# Application Note AN-1115

## IRS442(6,7,8) and IR442(6,7,8) Comparison

## Figures

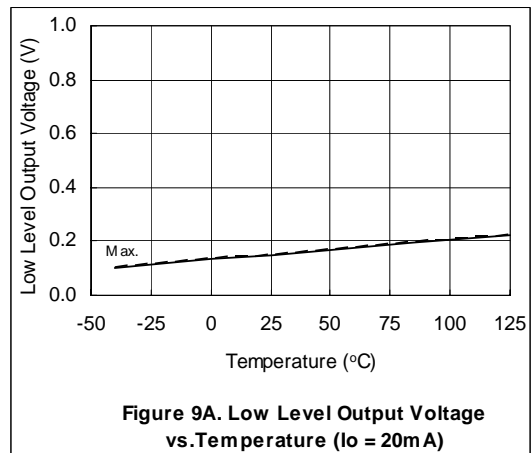
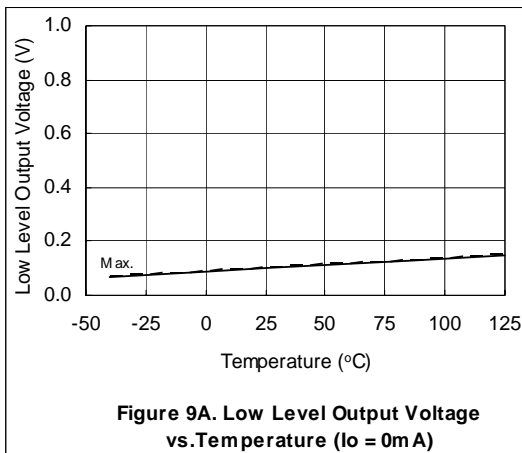
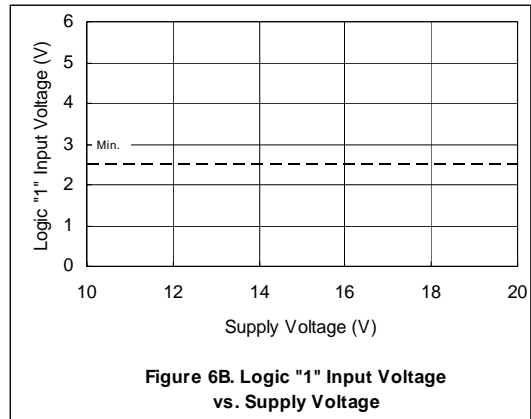
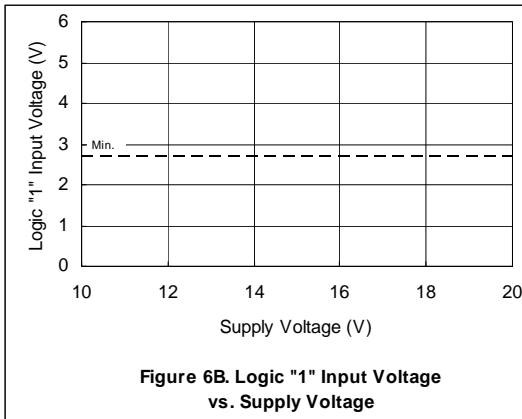
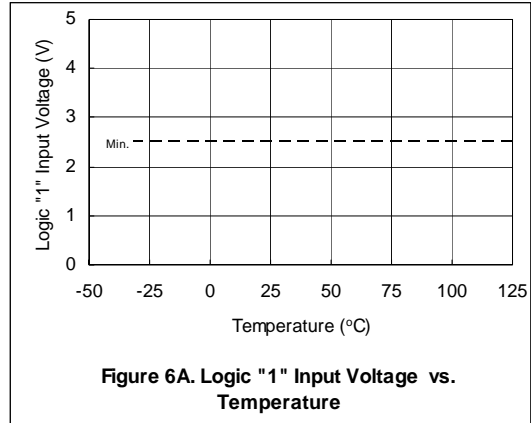
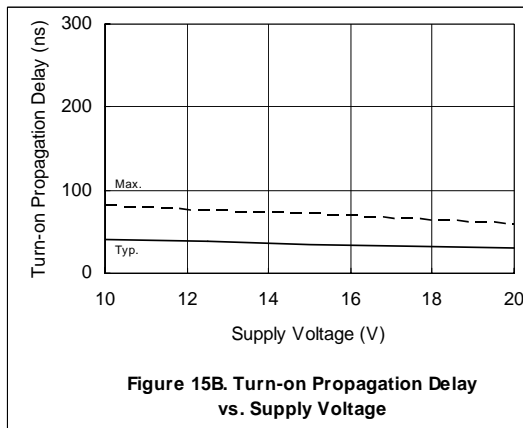
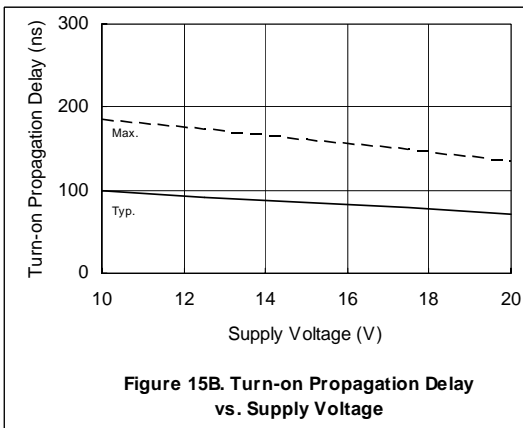
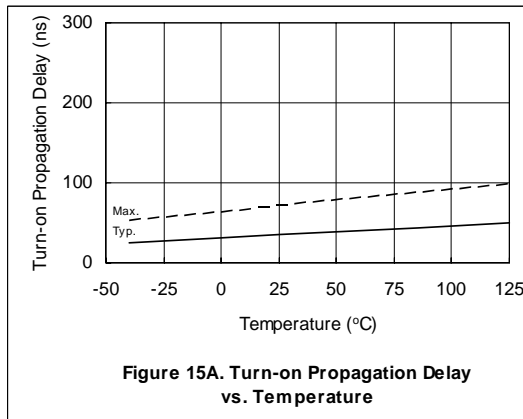
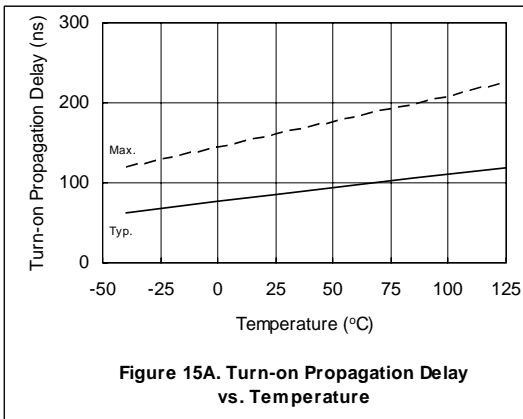
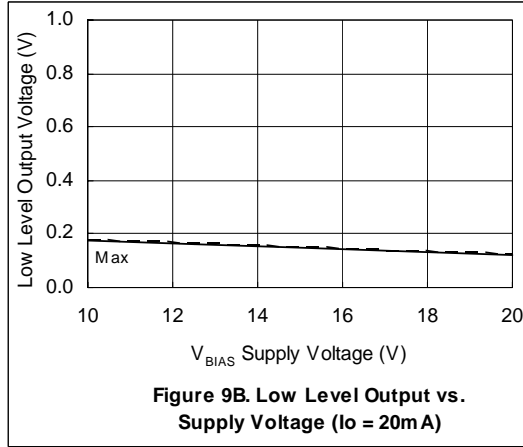
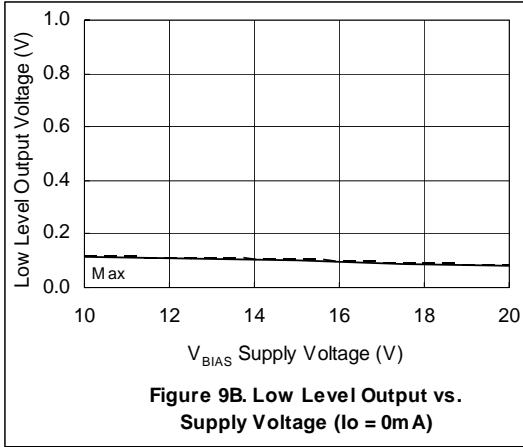
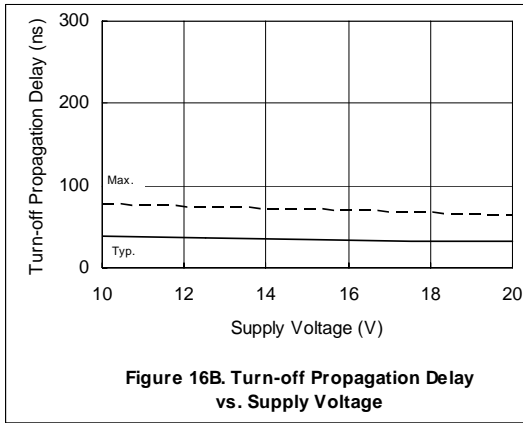
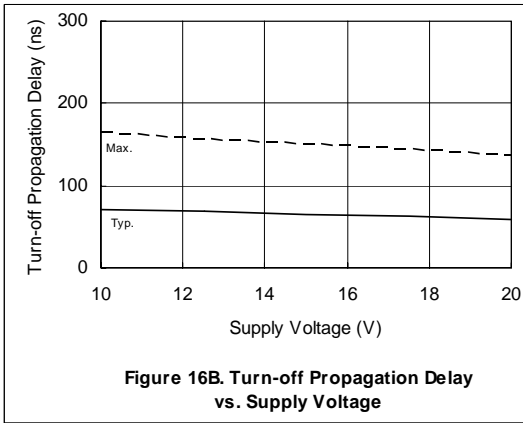
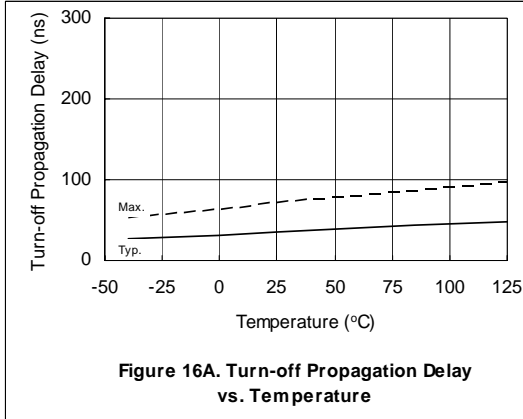
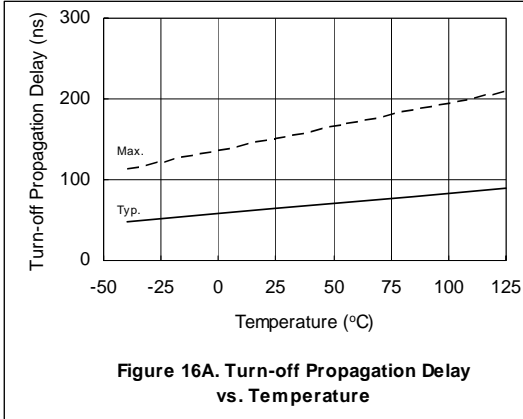
This figures shown in this section compare figures shown in the IR442(6,7,8) (left column) and IRS442(6,7,8) (right column) datasheets. Illustrations that have not changed between the two datasheets have not been included in this section.
